DER WEST				
DEVELO	DEVELOPMENT ASSESSMENT PANEL REPORT				
Application No.	Application No. REV/2025/0004				
Address	37 John Street LEICHHARDT				
Proposal	S8.2 Review of Determination No. DA/2023/1123 dated 10 December 2024 for demolition of existing structures, construction				
	of a new two storey light industrial development to John Street and				
	new warehouse with mezzanine office to Whites Creek Lane with				
	associated site works.				
Date of Lodgement	10 April 2025				
Applicant	JDS DP C/-Koturic & Co. Pty				
Owner	KRDJ Pty Ltd				
Number of Submissions Five					
Cost of works	\$1,889,070.00				
Reason for determination at	Review of determination of Planning Panel				
Planning Panel					
Key Considerations	Flood planning, matters raised in submissions				
Recommendation	Approved with Conditions				
Attachment A	Recommended conditions of consent				
Attachment B	Plans of proposed development

1. Executive Summary

This report is an assessment of the application submitted to Council under Section 8.2 of the *Enviromental Planning and Assessment Act 1979* to review the refusal of Determination No. DA/2023/1123 dated 10 December 2024 which sought the demolition of existing

Figure 2. Flood Certificate (provided by Council)

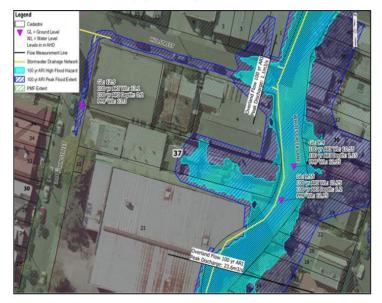
- c. The floor levels at the John Street frontage have not been set at the flood planning level for John Street as required by Control C4 (E1.3.1). The Flood Certificate indicates that the 1 in 100 year flood level in John Street adjacent to the site is 13.1m AHD which is 110mm above the driveway/footpath level and therefore overland flows will enter the property from John Street and flood the garage and industrial units which are below the footpath level. A side setback is required to address these overland flows and prevent inundation of the Industrial units in accordance with Control C2 (E1.2.2);
